N9951A-01A

Modification Recommended Service Note

N9951A – 44 GHz FieldFox RF analyzer

The Problem – The internal Main Memory (SD) card can fail. Refer to www.keysight.com and the **Contact Keysight** link.

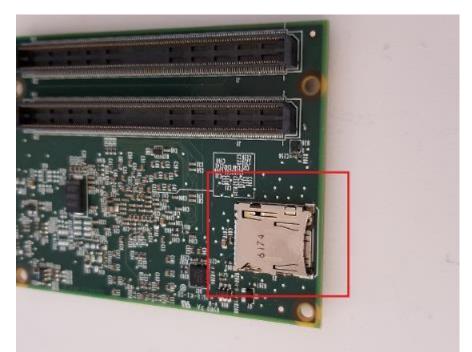
c. Using an Exacto Knife remove the Epoxy bridge holding the SD Card into the SD card socket.

d. Use caution to not damage the socket or other parts of the CPU board.

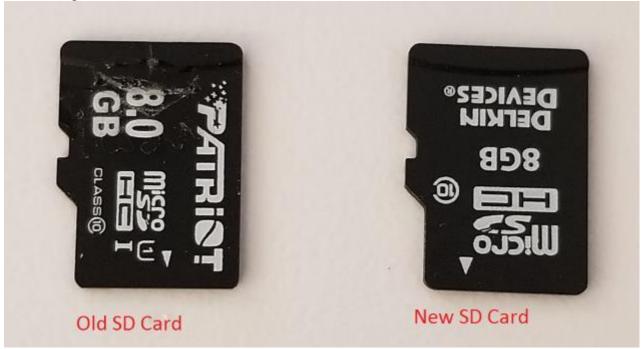
e. To remove the SD card, press the SD card slightly in towards the socket, it will click and then release to remove the SD card. Remove any extra epoxy that may be left.

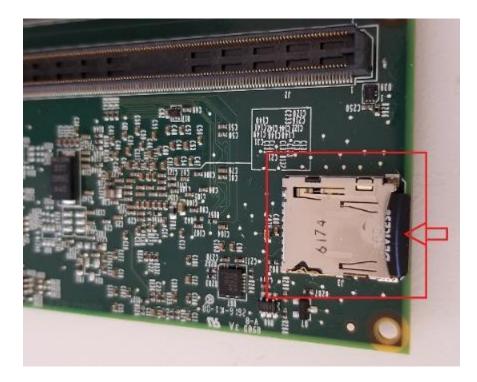
f. Here are the Old and New SD cards. The old SD card (Patriot) is on the left. The New (Delkin) is on the right.

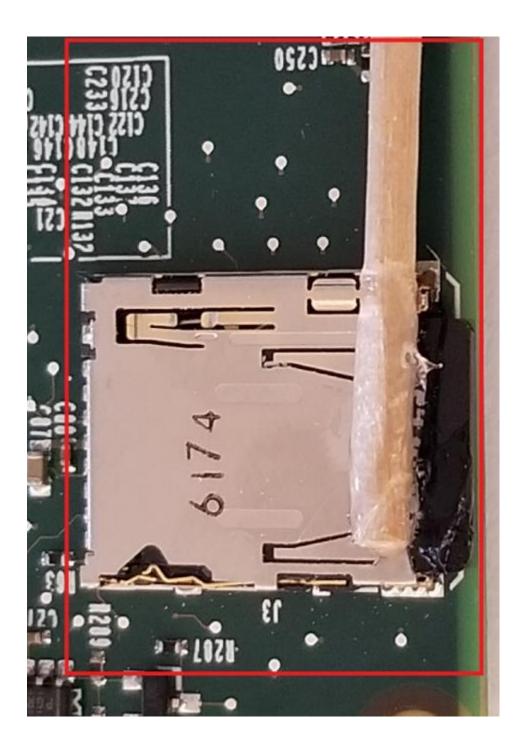
g. Insert the NEW SD card into the SD card socket and press it in until you hear a click, then release. The SD card is now locked in the socket.

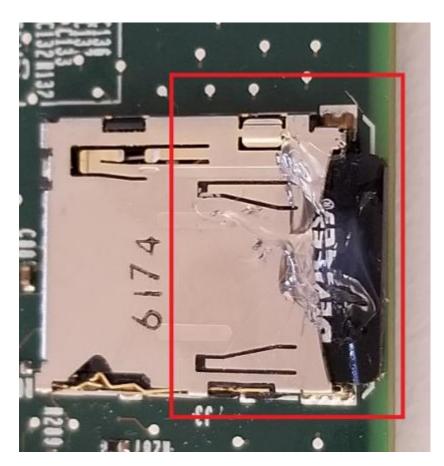
h. It is now necessary to add a small amount of RTV (part number 0470-0450) to bridge the SD card to the SD card socket. Using a wooden Q-Tip place a small amount of RTV on both the SD card and the socket.
